SB Number:	SB 2HS-002	Creation Date: 14/01/2009
Subject:	<i>Paper jam, actuator of registration sensor does not move freely</i>	
Model:	FS-1100/1300D

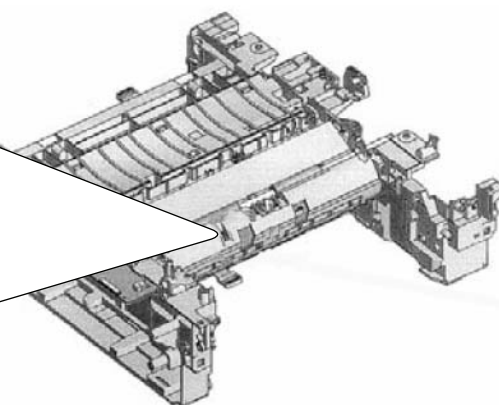
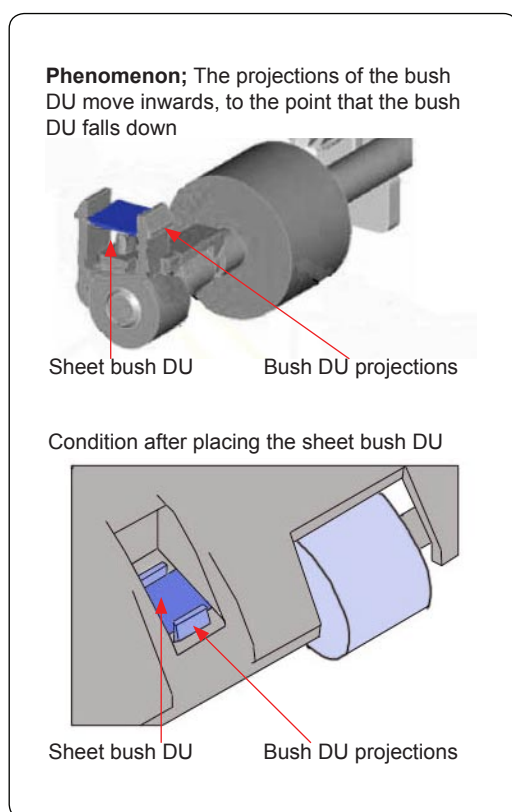
Phenomenon	A paper jam may occur if the actuator of registration sensor (302HS24060) does not move freely.
-------------------	---

Cause	The projections of the bush DU may move inwards, resulting in that the bush DU drops from the base frame, pushing the actuator of registration sensor downwards. This may occur when the machine receives a shock (E.G. machine is dropped on a surface).
--------------	--

Solution	Place sheet bush DU between the bush DU projections to improve the fitting.
-----------------	---

Parts	No.	Old Parts No.	New Parts No.	Description	Q'TY		Interchangeability		SP
					Old	New	Old	New	
	1	-----	302HS02700 2HS02700	SHEET BUSH DU	-	1	-	O	-
